World Forum for Harmonization of Vehicle Regulations

Proposal for Supplement 4 to the 03 series of amendments to UN Regulation No. 129 (Enhanced Child Restraint Systems)

Submitted by the Working Party on Passive Safety *

Figure 2
ECRS Measurement Device - Side and Front View of the measuring device

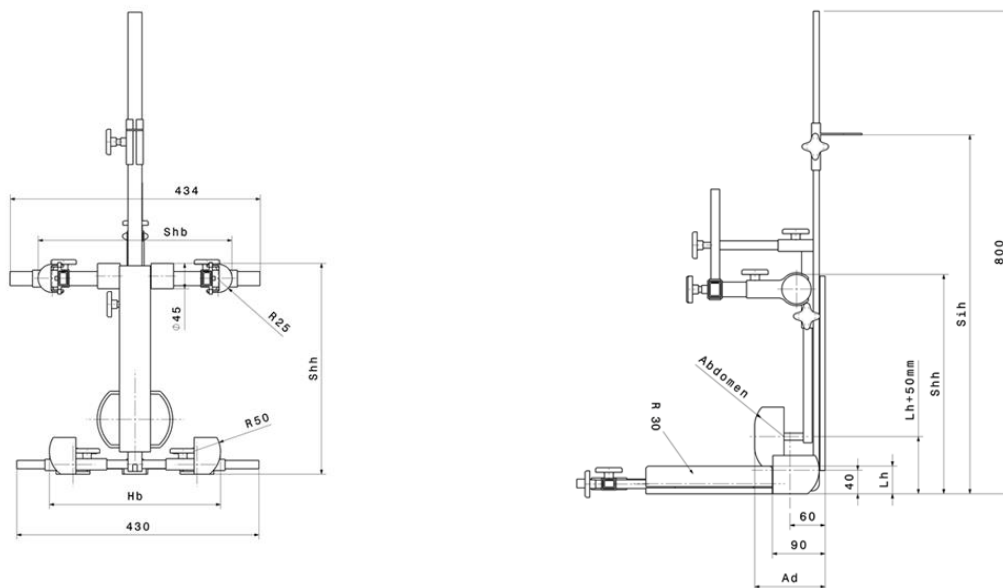
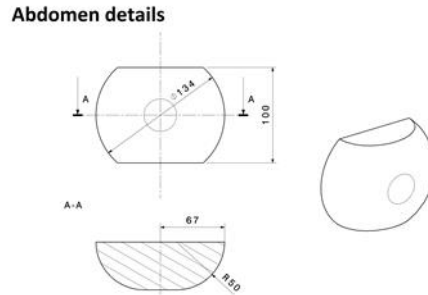
Annex 18., amend to read:

Geometrical dimensions of Enhanced Child Restraint Systems

For integral or non-integral ECRS the device shown in Annex 18, Figure 2 shall be used.

The mass of the devices described in Figure 2 and Figure 3 shall be 10 kg +/- 1 kg.
